Appendix 2

Agency Coordination

Subject: Draft General Conformity Determination for the Houston Ship Channel Project Deficiency Report (Flare at the Intersection of the Houston Ship Channel and Bayport Ship Channel), Chambers County

**Documentation of Emission Estimates for General Conformity
Houston Ship Channel (HSC) Project Deficiency Report (PDR) for the HSC Flare at
the Bayport Ship Channel
DRAFT
22 July 2015**

Figure 1: Preferred Alternative for Bayport Flare

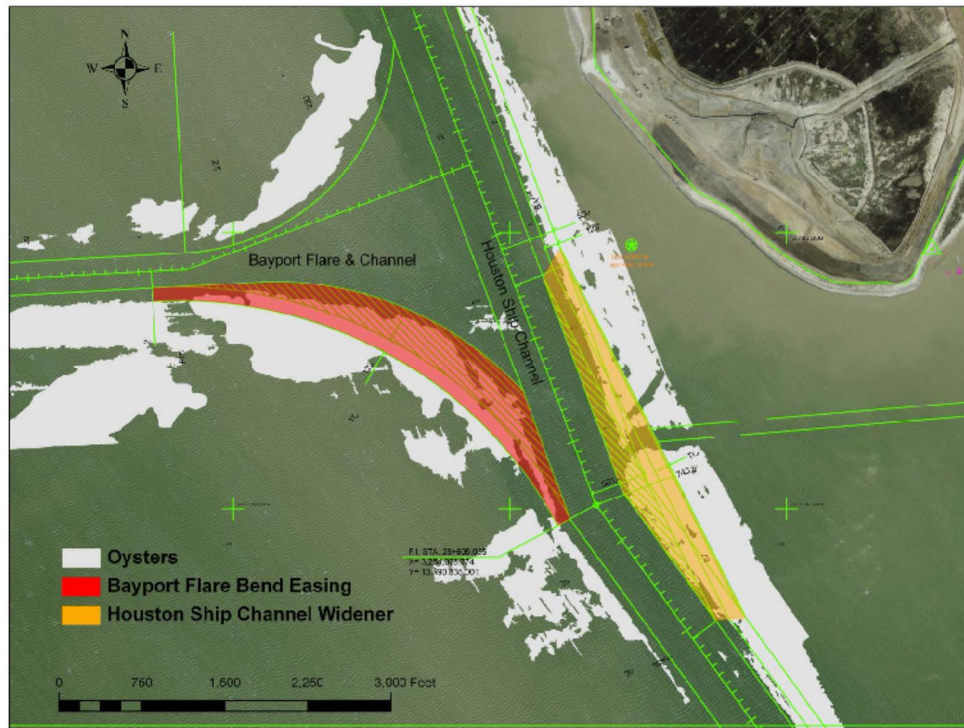
The Service believes the Preferred Alternative will have permanent impacts on fish and wildlife resources (oyster reef). Therefore, mitigation is recommended for permanent impacts to oyster reefs found within the Preferred Alternative footprint. In addition, the Service recommends that the Corps evaluate and provide compensatory mitigation for any indirect impacts associated with the proposed project. At this time, the Corps plans to mitigate direct oyster impacts at a ratio of 1:1 at one of three potential sites in Galveston or Trinity Bays. However, the Service recommends the Corps conduct functional assessment modeling efforts using the American Oyster Habitat Suitability Index model to assist in determining the appropriate amount of mitigation that is commensurate with both direct and indirect impacts.

The Service also recommends continued coordination with the BUG and TPWD to finalize the mitigation site selection once all alternatives and formal mitigation/monitoring plans have been fully evaluated. All mitigation and monitoring plans should be evaluated by the BUG prior to

Monitoring efforts and associated reports should not be limited to oyster density, but should include oyster size, frequency, spat density, associated fauna, reef size, reef architecture, fragmentation, salinity, temperature, turbidity, and dissolved oxygen when conducting the twice-a-year assessment. These criteria should be evaluated at each mitigation and reference site. Summarized reports should be submitted annually to the BUG for review and comment and should continue as outlined in the formal monitoring plan; however the Service recommends a minimum of three years of monitoring.
